Intel® Mobile Pentium® III Processor Specification Update

Release Date: August 2000

Order Number: 245306-010

Figure 7. BCLK Timing Waveform

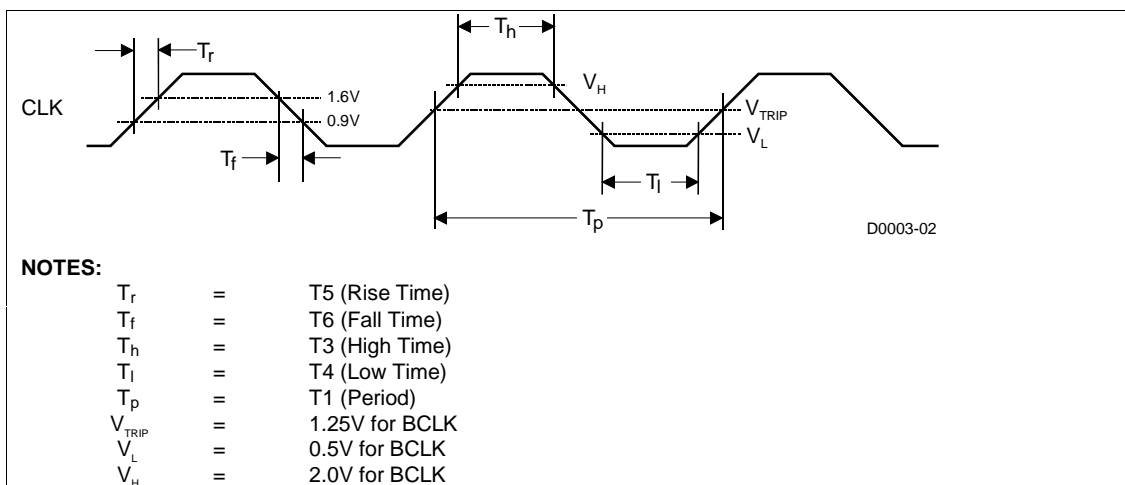
For B0 step processors, the $V_{IH,BCLK}$ Min spec is changed to 2.0V (from 1.7V for A2 step) and $V_{IL,BCLK}$ Max spec is changed to 0.5V (from 0.7V for A2 step). Due to this, new values are specified for BCLK high and low times for B0 step processors. These modifications affect corresponding specs in Table 13, Table 14, Table 24, and Figure 7 in *Mobile Pentium® III Processor in BGA2 and Micro-PGA2 Packages datasheet* (Order Number 245302-002).

The following tables and figures highlight the above mentioned BSEL[1:0] and BCLK specs modifications made for B0 step processors:

Symbol	Parameter	Min	Typ	Max	Unit	Figure	Notes
	System Bus Frequency		100		MHz		
T1	BCLK Period		10		ns	Figure 7	Note 2
T2	BCLK Period Stability			± 250	ps		Notes 3, 4
T3	BCLK High Time	2.70			ns	Figure 7	at >2.0V
T4	BCLK Low Time	2.45			ns	Figure 7	at <0.5V
T5	BCLK Rise Time	0.175		0.875	ns	Figure 7	(0.9V – 1.6V)
T6	BCLK Fall Time	0.175		0.875	ns	Figure 7	(1.6V – 0.9V)
